**DOCUMENT 00 90 00**  
**ADDENDUM**

**ADDENDUM NO. [1]**                      **Date: June 30, 2022**

**RE:                      CITY OF ABBOTSFORD CONCESSION STAND & PRESS BOX**  
**407 W. HEMLOCK ST.**  
**ABBOTSFORD, WISCONSIN 54405**  
**PROJECT NO. 22002**

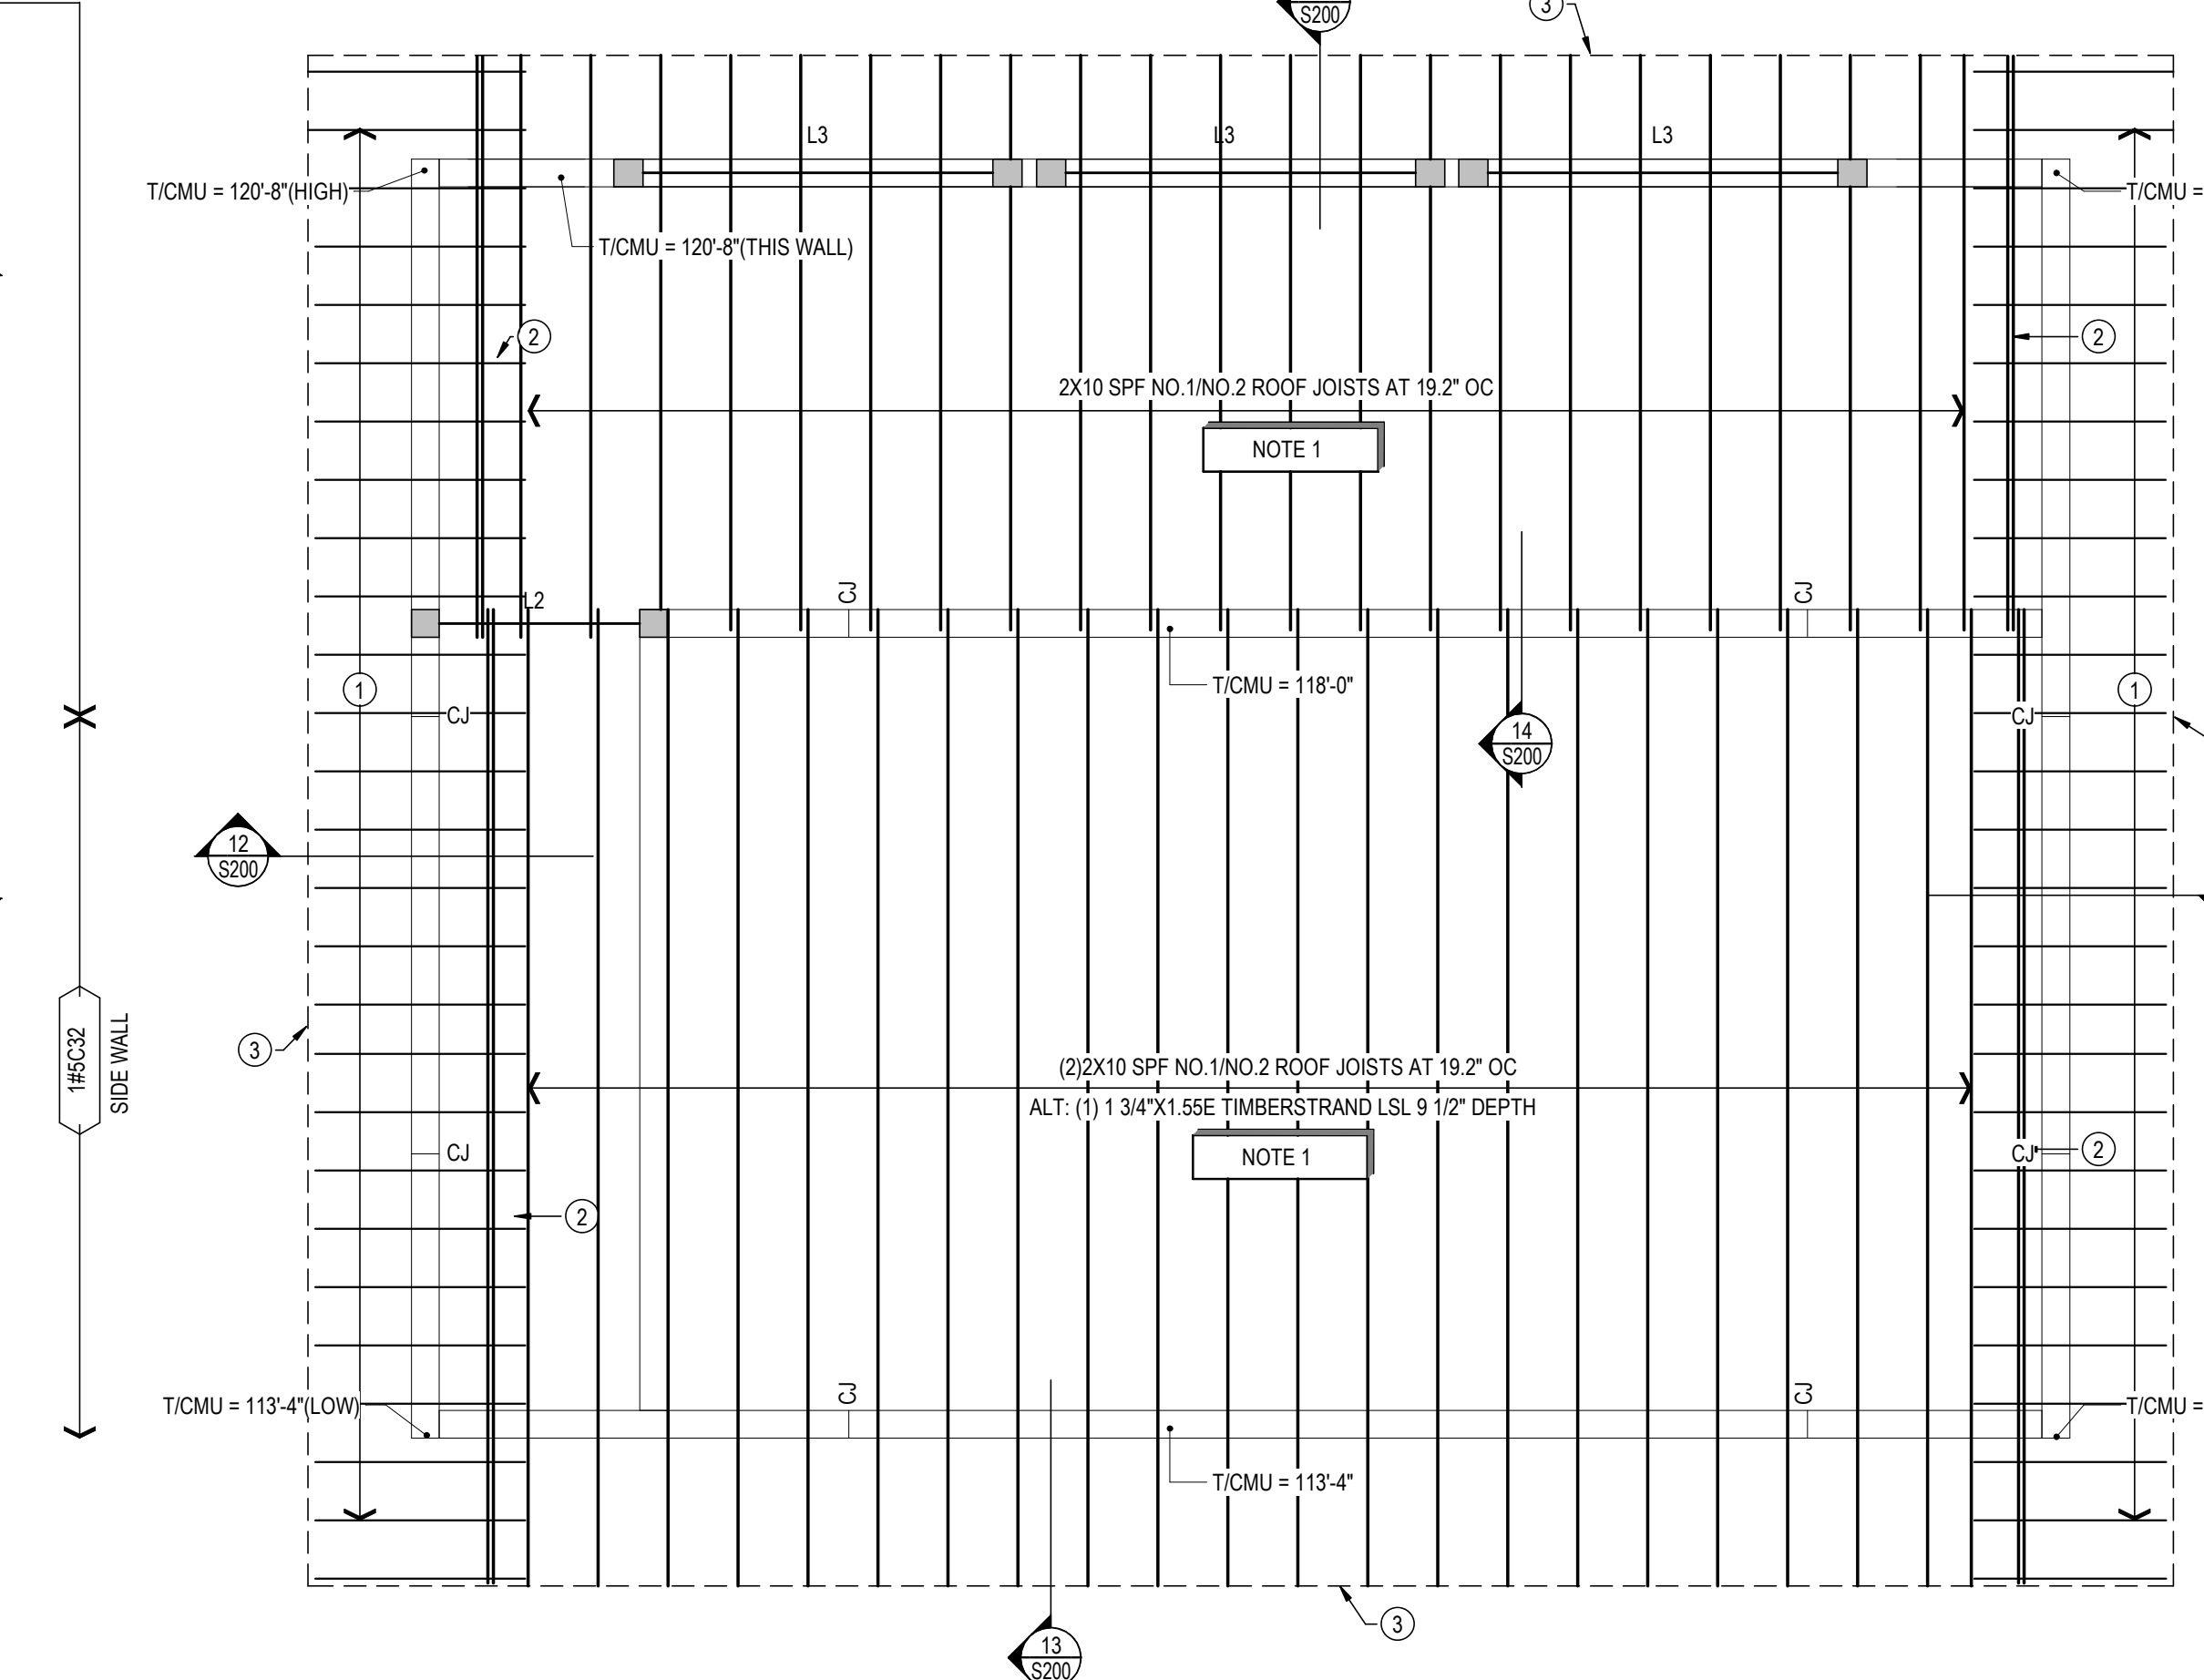
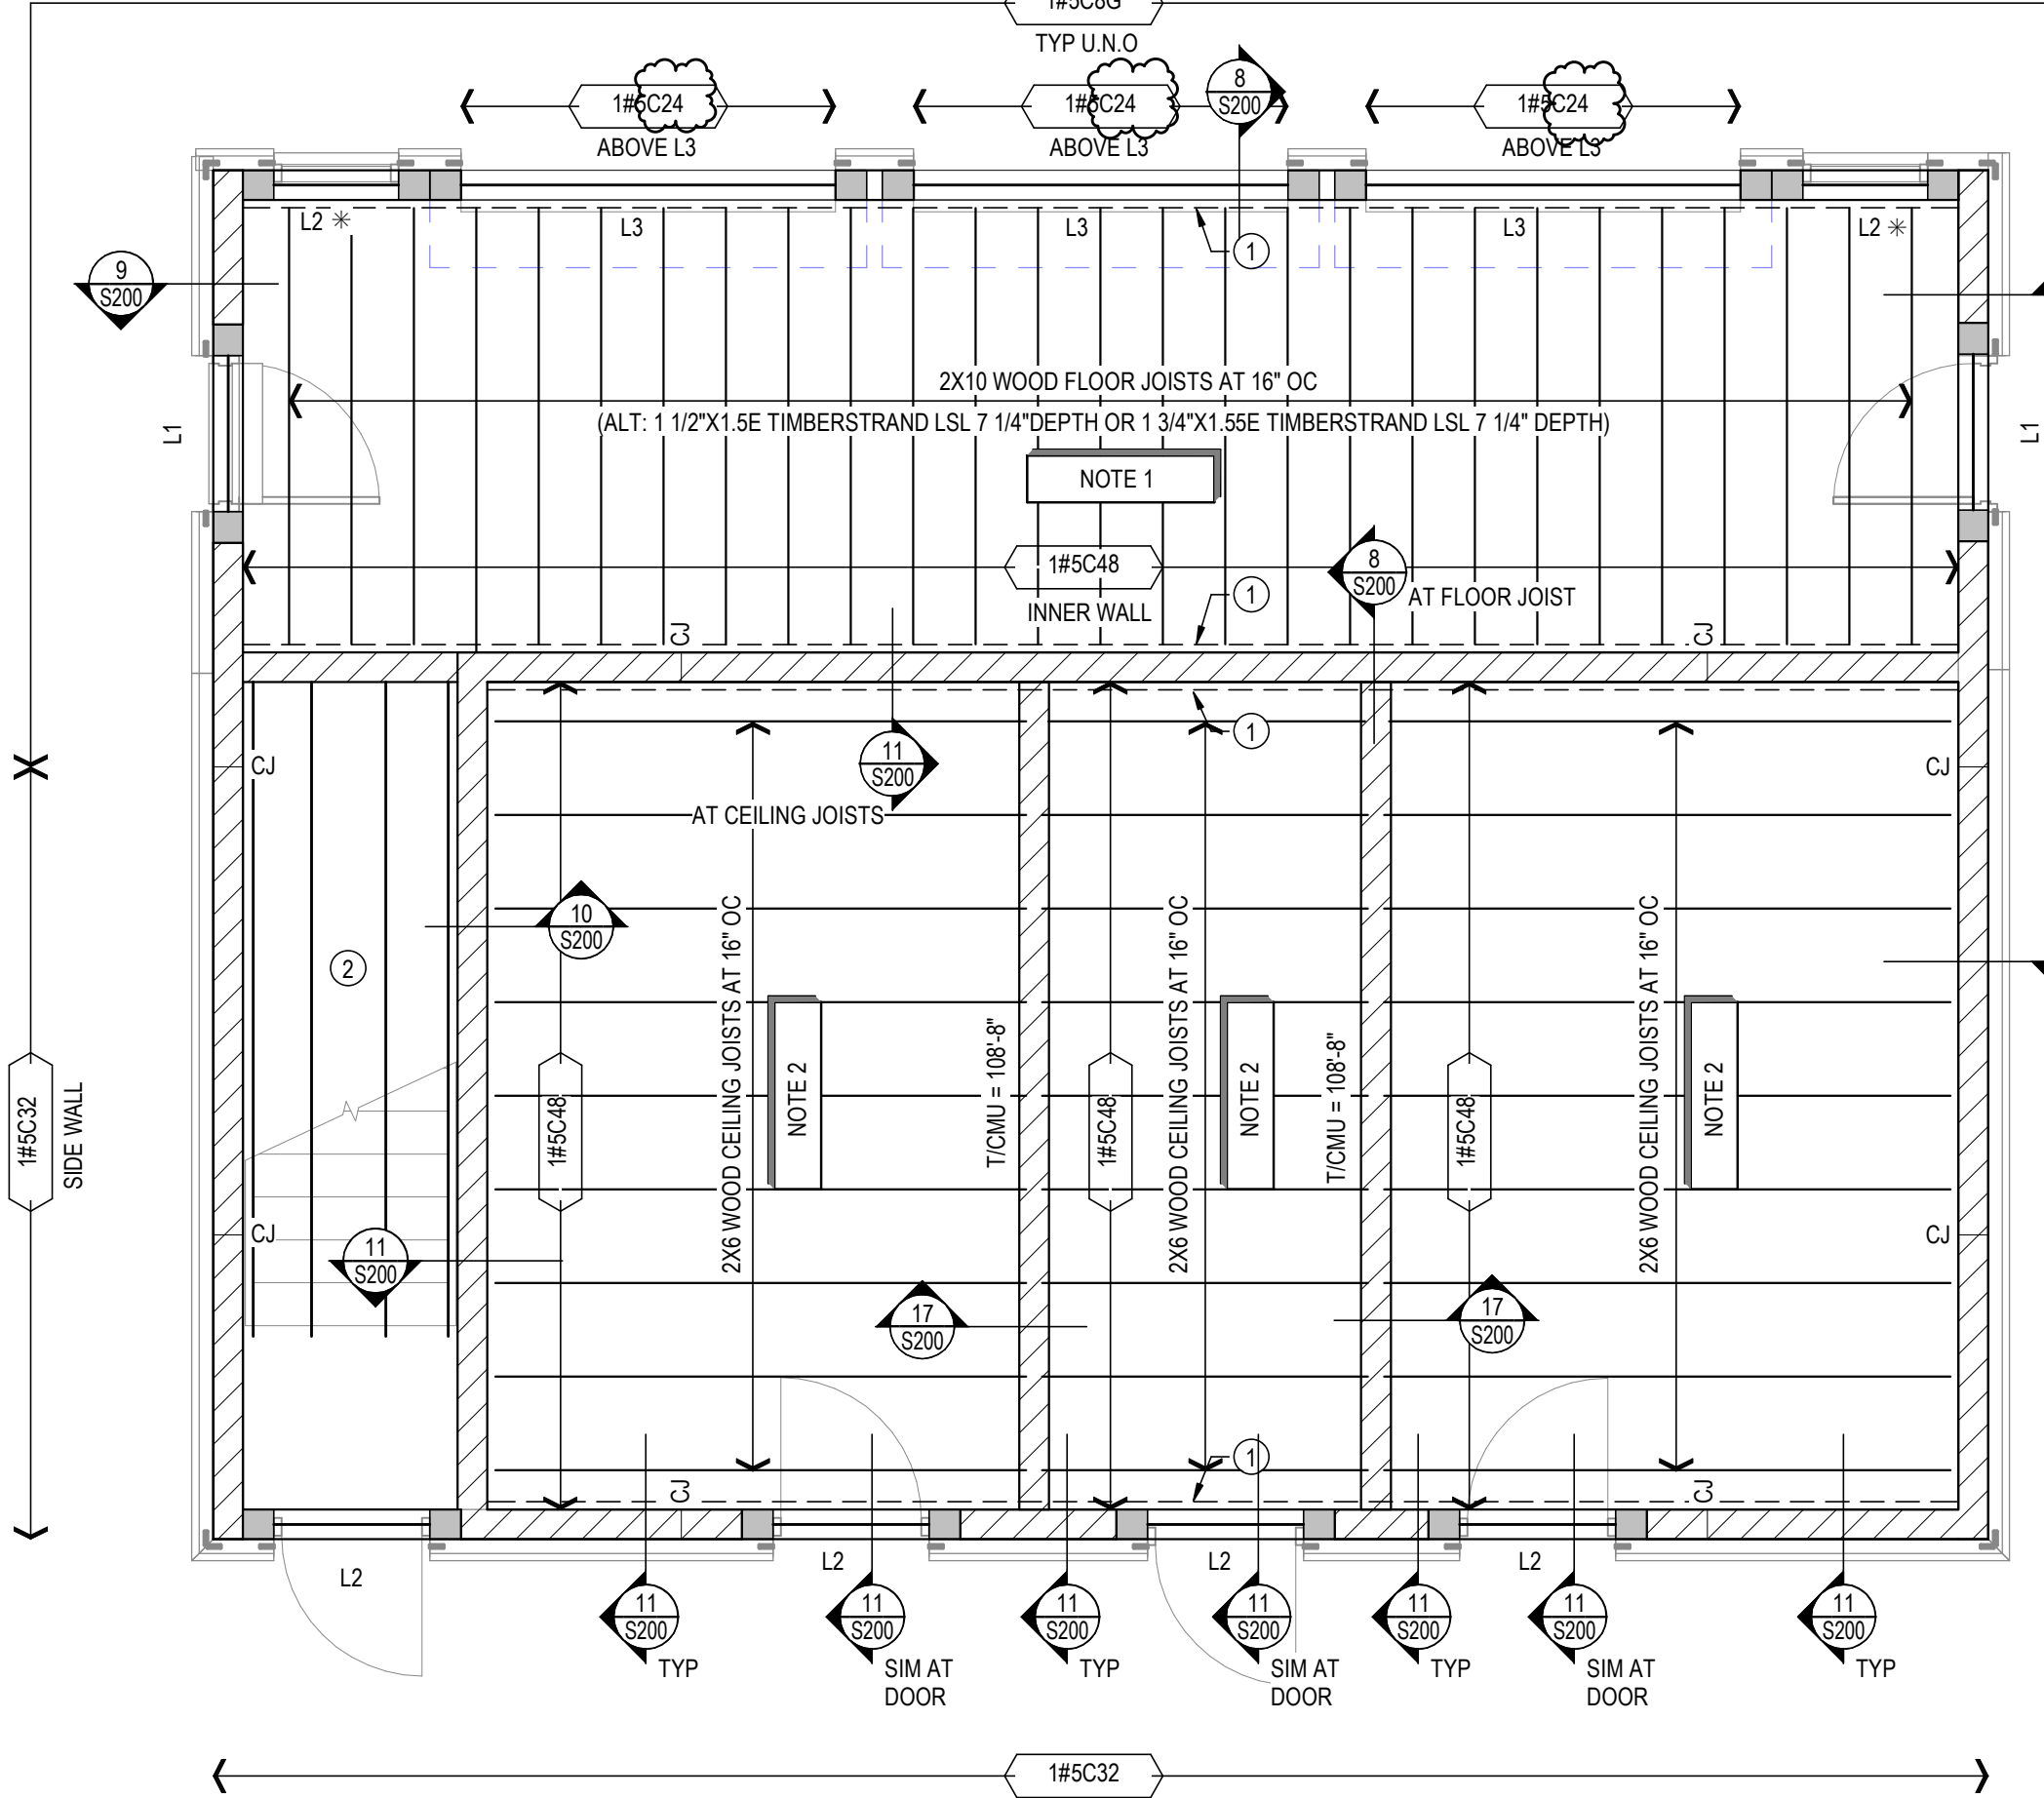
1. AS SPECIFIED FOR WC-1 EXCEPT MOUNT RIM 18\* ABOVE FLOOR.
2. Sheet S200: FRAMING PLAN - 30" X 42"
  - a. See the revised sheet included in this addendum. Disregard the previous version.
  - b. Add Masonry Wall Vertical Reinforcement Legend to the sheet.
  - c. Revise three masonry wall reinforcement marks clouded on north side of 1/S200.
